Sub: Functionality of automatic fire detection cum suppression system fitted in Pantry/Power cars.

(Coach Alteration Instruction No. CAI/RCF/MECH/LHB/064)

1. Description Retro fitment of locking arrangement of isolating cock of Aspiration type smoke/ Fire detection with Alarm system in LHB AC Coaches.
2. Ref As per instructions of DG/Safety, Railway Board during visit to RCF, Kapurthala on 10.04.24.
3. Reason for alteration To prevent the tampering of isolating cock of Aspiration type smoke/ Fire detection with Alarm system in LHB type Coaches.
4. Coach type & Applicability of Drawing Number All LHB AC coaches.
5. To be carried out

| WELD LENGTH | ITEM | DESCRIPTION & DIMENSIONS | QTY | DETAIL DRG | MATL. & SPEC. | REMARKS |
|---------------|----------------|-----------------------------------|--------------|------------|---------------|---------|
| NIL | M | DRG. NO. MI008044 | | | | |

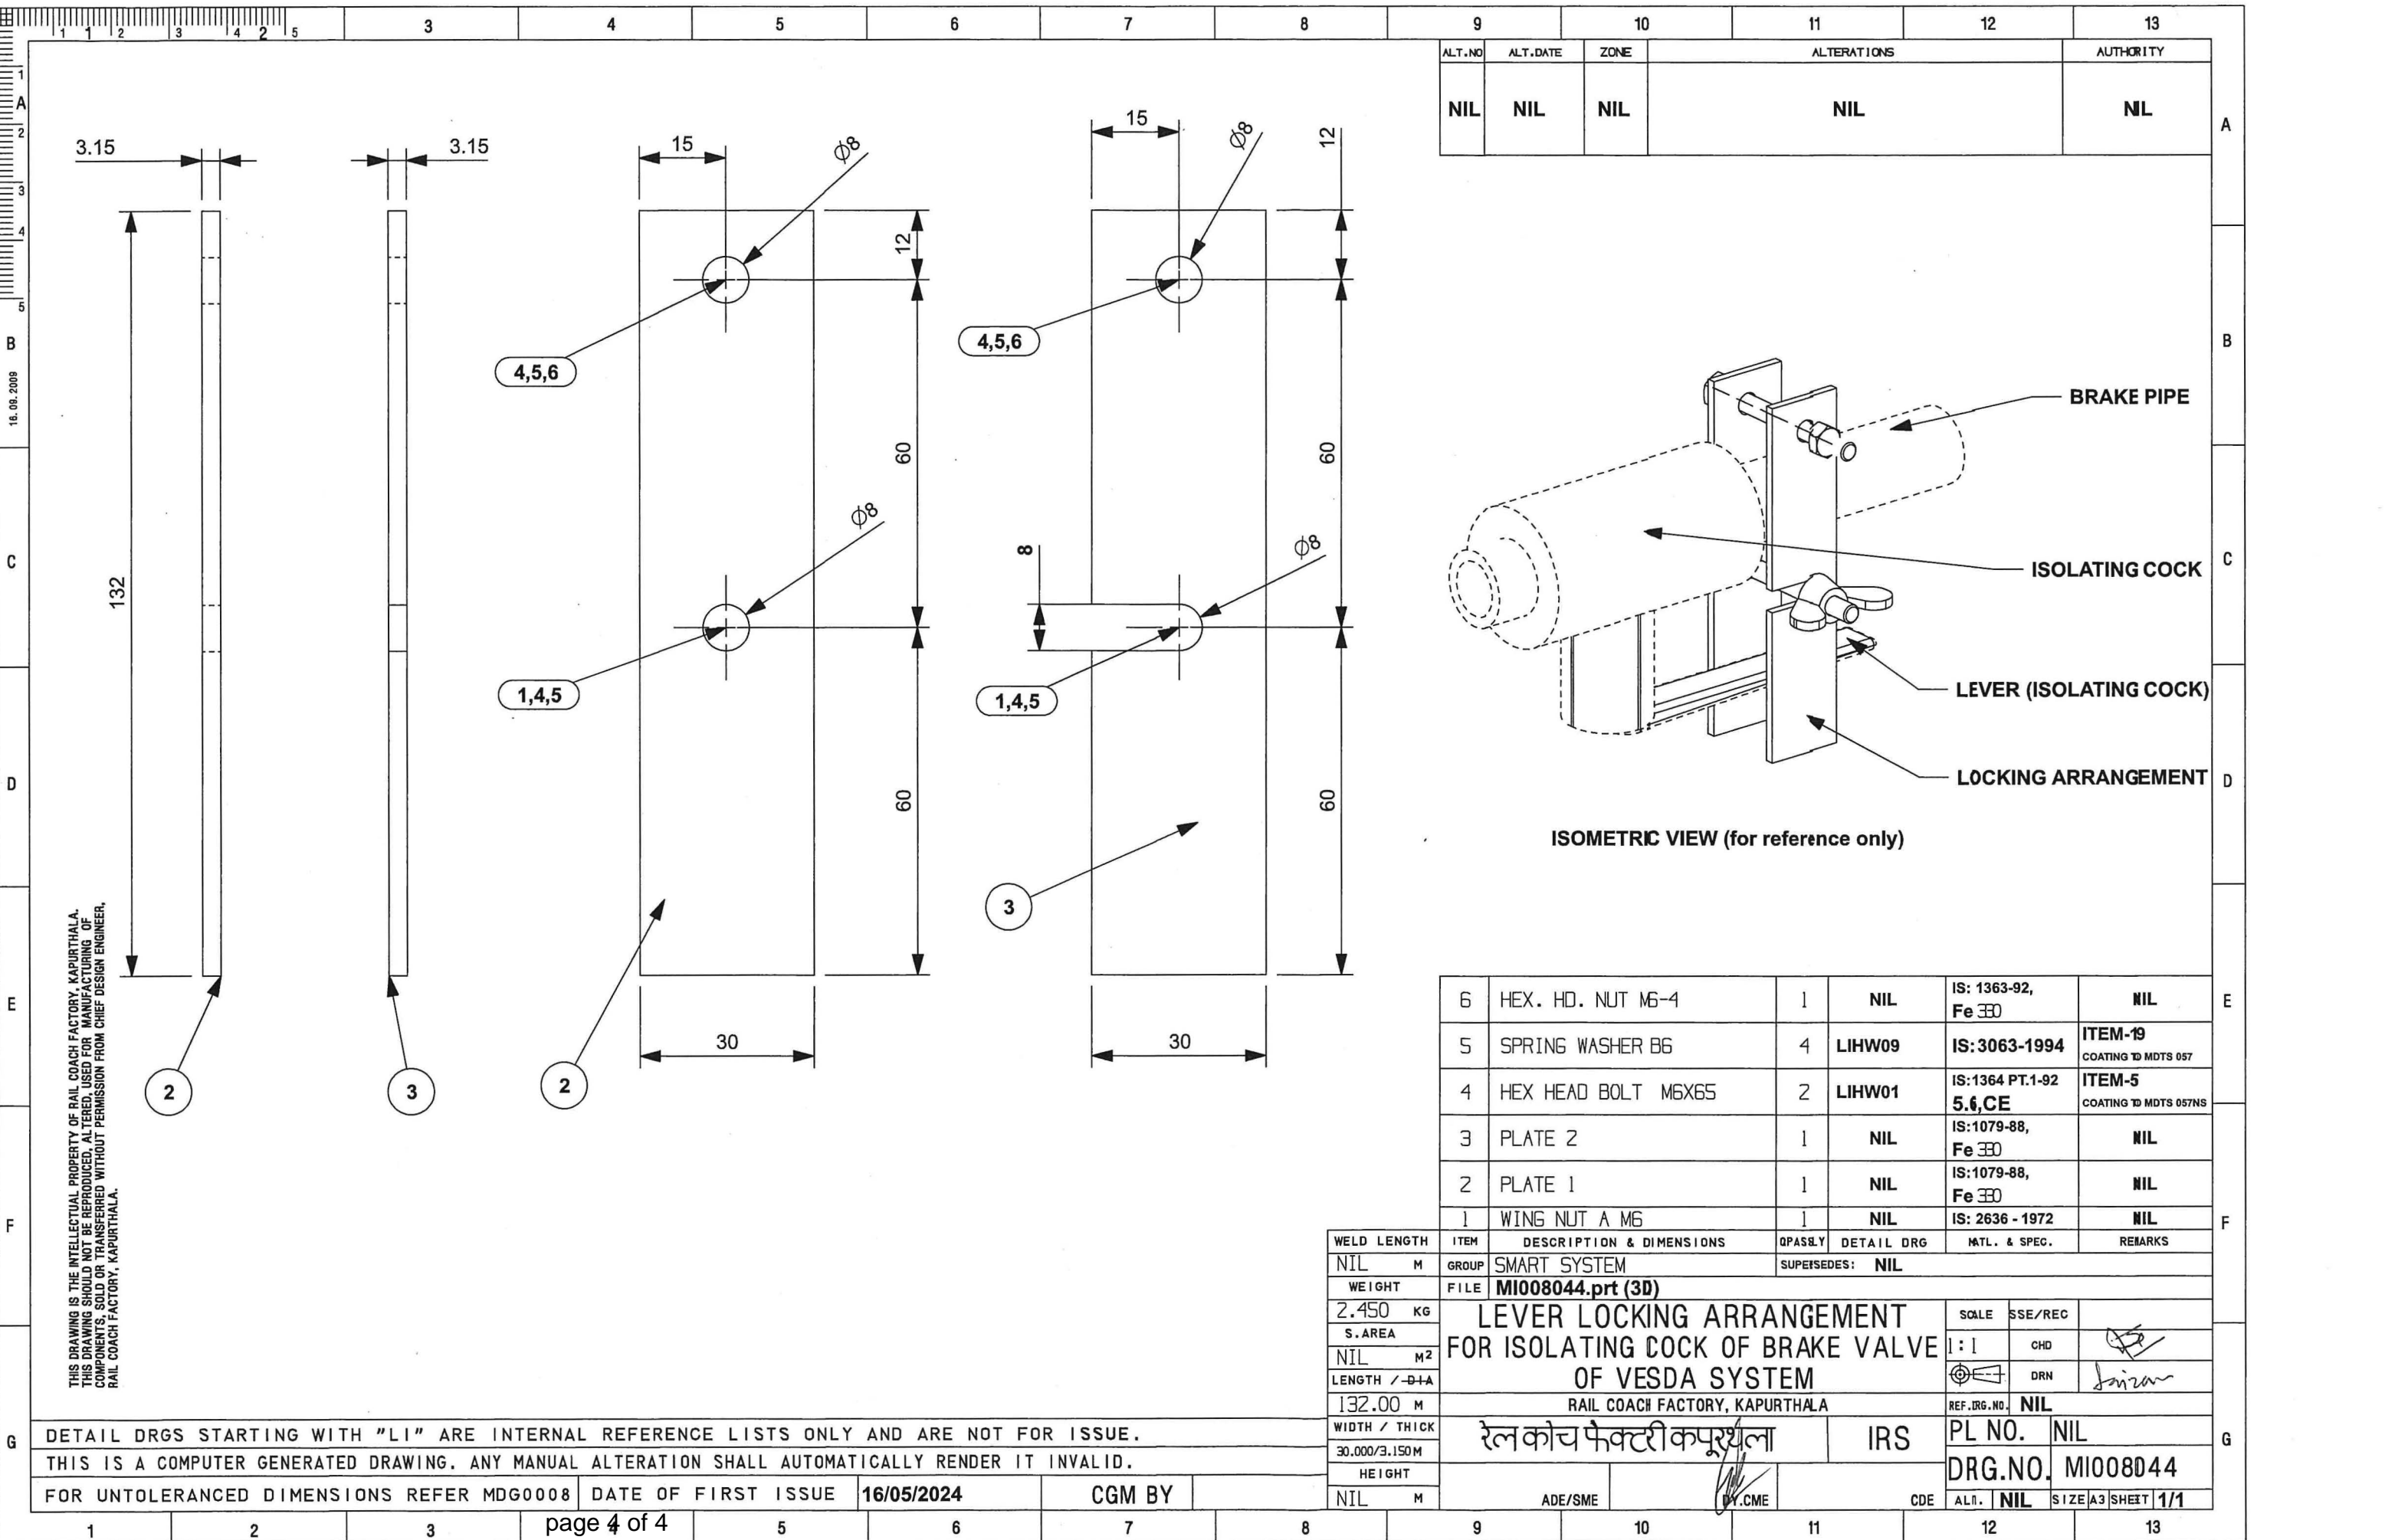
6. Special Instructions:
 - i. Bracket should be properly clamped on brake pipe to prevent the unauthorized movement of lever of isolating cock.
 - ii. All other required items already incorporated in the drawing as provided in MI008044.
